**FAQ Number** 07-0038 Revision 3

**FAQ Title** Lessons learned on Multiple Spurious Operations

Plant: Turkey Point

Date: November 4, 2010

**Figure XX – Multiple Spurious Operations – Transition Resolution Process**

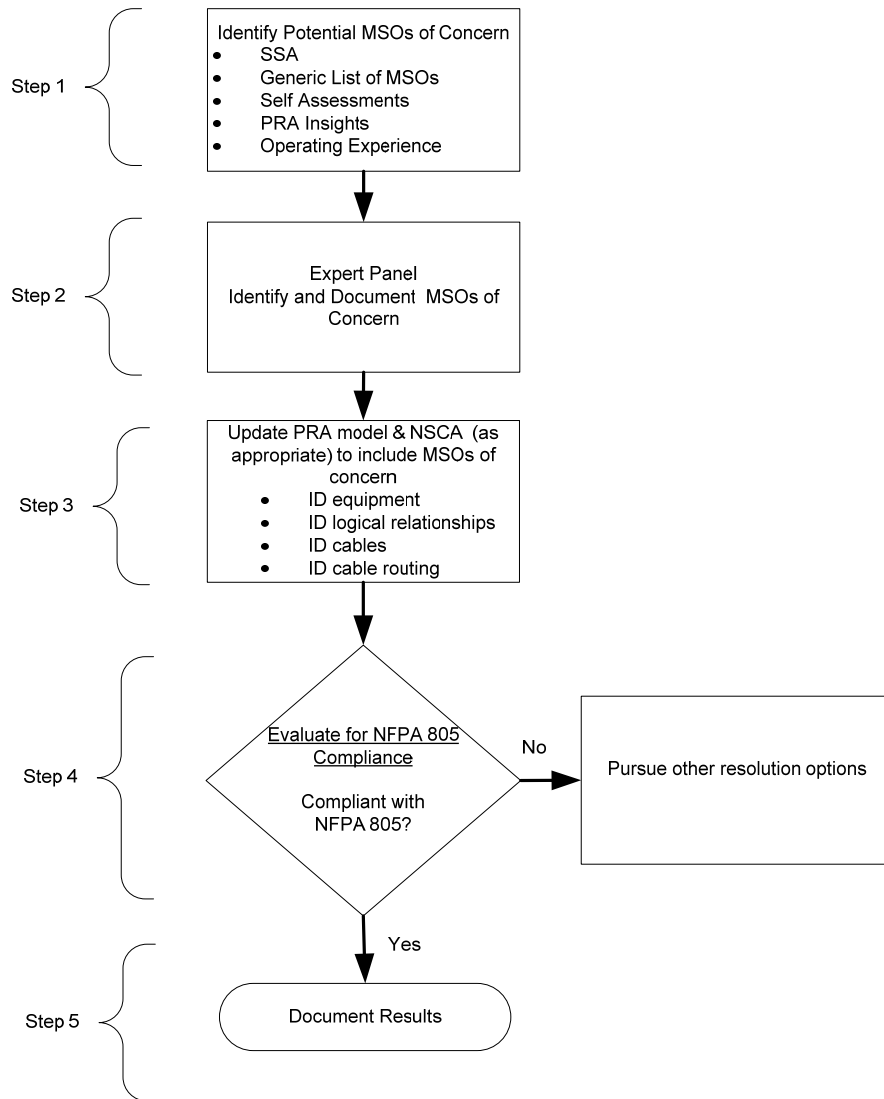
The approach outlined in Figure XX below is one acceptable method to address fire-induced MSOs. This method uses insights from a Fire PRA that meets the requirements of Regulatory Guide 1.205, Revision 1.

This process is intended to be in support of transition to a new licensing basis. Post-transition changes would use the risk-informed, performance-based change process. The post-transition change process for the assessment of a specific MSO would be a simplified version of this process, and may not need the level of detail shown in the following section (e.g., An expert panel may not be necessary to identify and assess a new potential MSO. Identification of new potential MSOs may be treated as part of the plant's Operating Experience process.
